RE: FEMA'S FLOOD MAP REVISION FOR THE PROPERTY, 1315 WHITEHEAD STREET, KEY WEST, MONROE COUNTY, FLORIDA

FEMA Letter of Map Revision (LOMR) Application

**1315 Whitehead Street
Key West, Florida**

FIGURE 2
EXISTING FEMA FLOOD ZONES

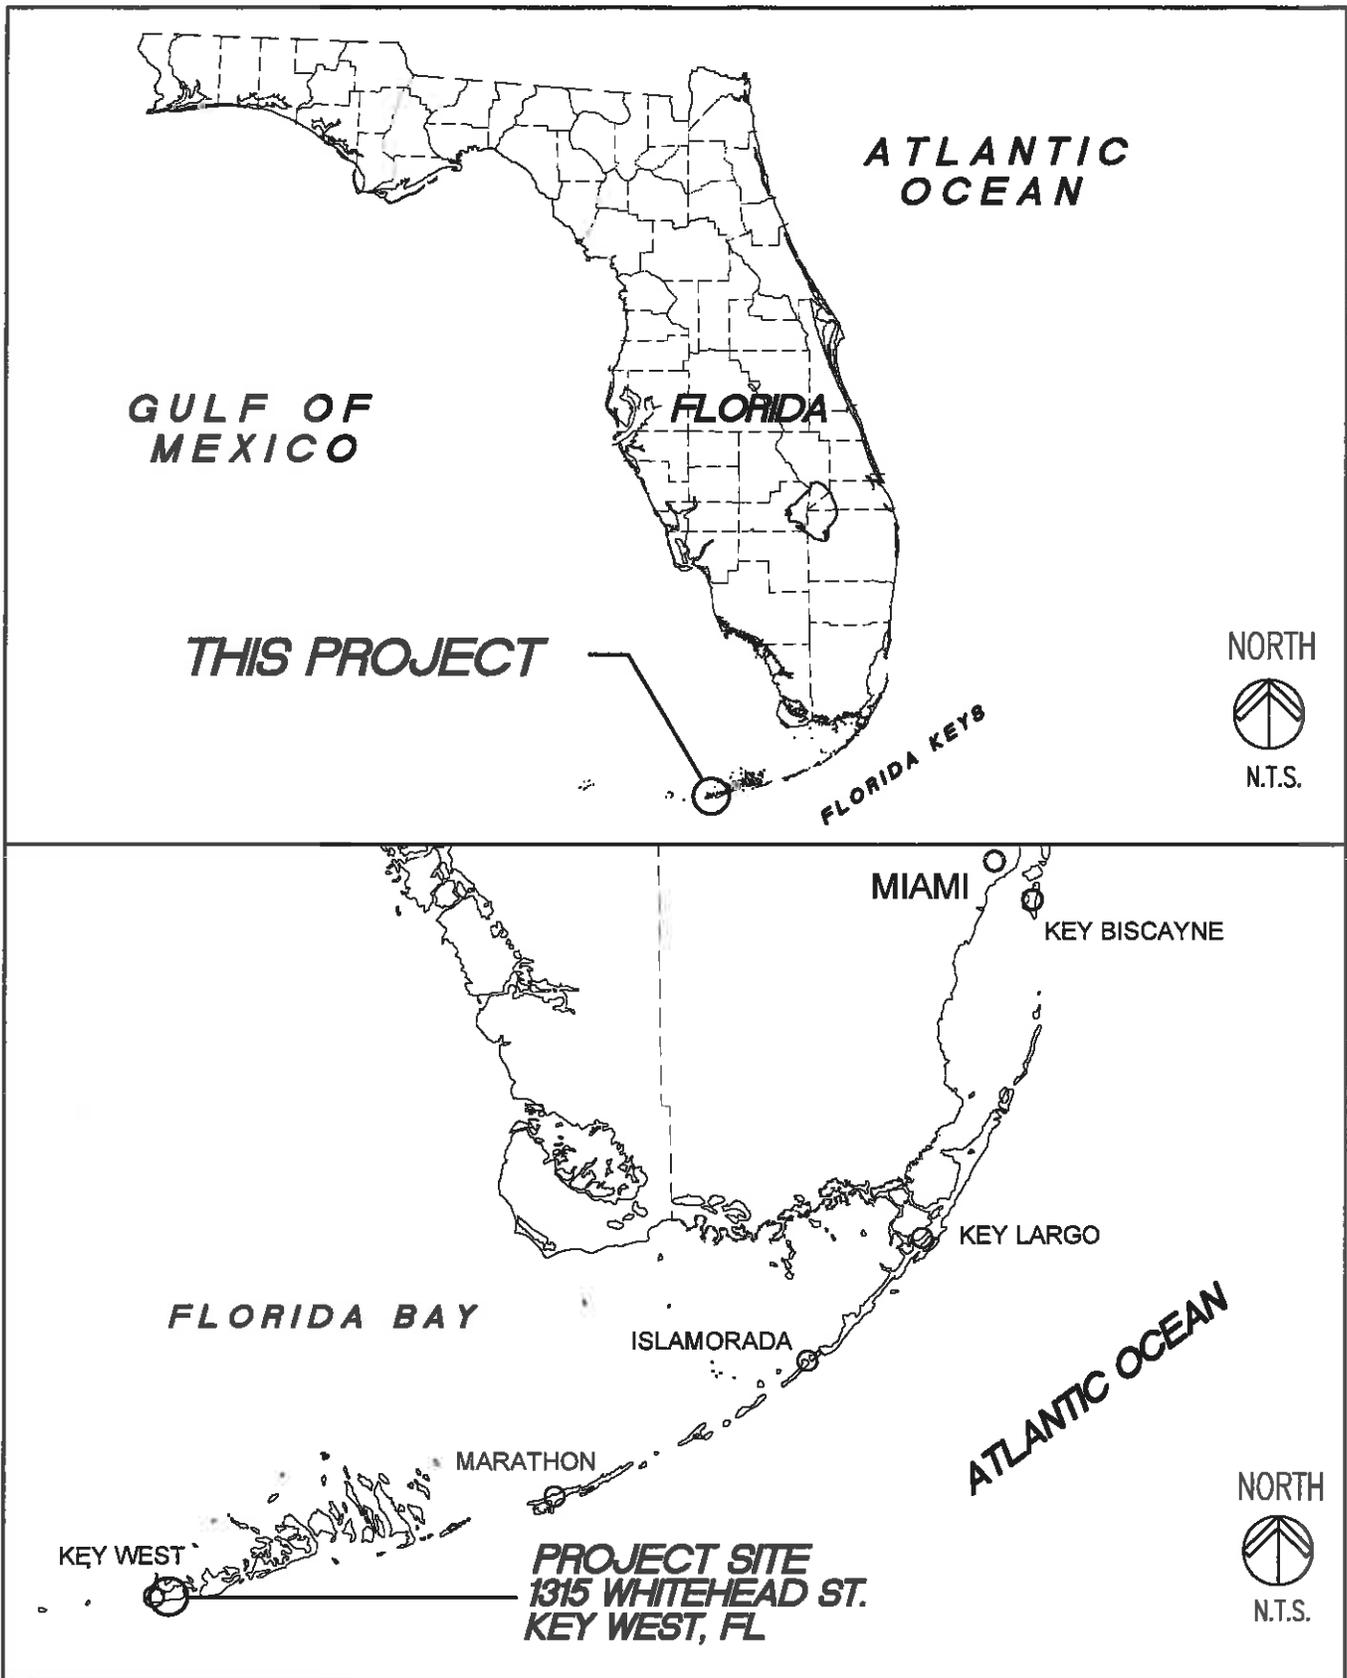
From the current FEMA's FIRM (No. 12087C1516K, Feb. 2005), the project area is bisected by two (2) VE flood zones ("Coastal High Hazard Area") with base flood elevations ranging from 10 to 12 feet NGVD as shown in Figure 2. These flood zone designations were determined by FEMA based on interpretation of the results of their wave height analysis along Transect No. 2 as documented in the FIS (2005).

FIGURE 4
ANNOTATED FLOOD INSURANCE RATE MAP

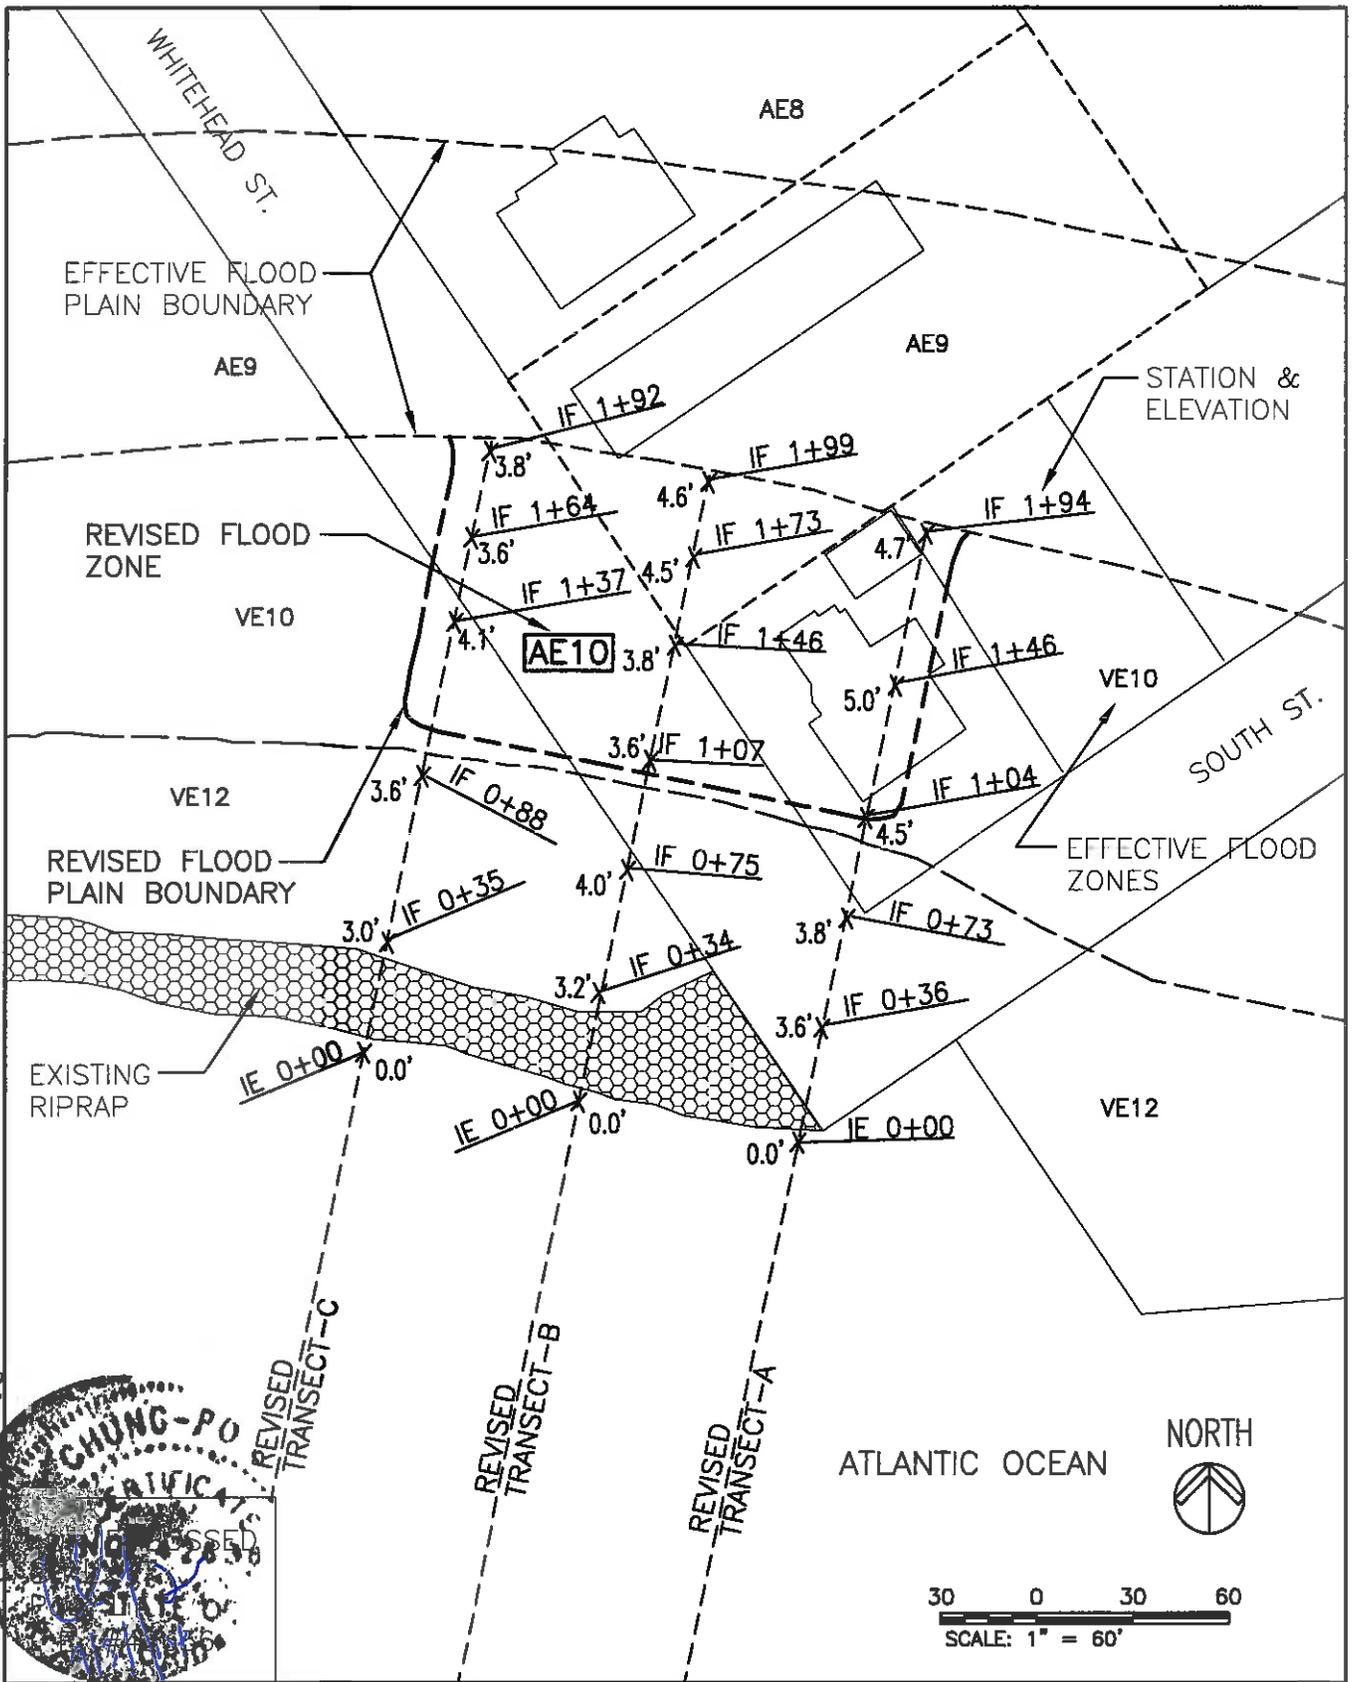
The results of the revised WHAFIS model reanalysis demonstrate that with consideration of the site-specific topographic data, the revised AE/VE floodplain boundary along the new transects would shift a maximum of 96 feet seaward from its current location (Figures 3 and 4). Under the revised flood zone, a portion of the subject property will lie within the new AE10 flood zone. The revised WHAFIS model input and output files supporting this reanalysis are presented in Appendix-B.
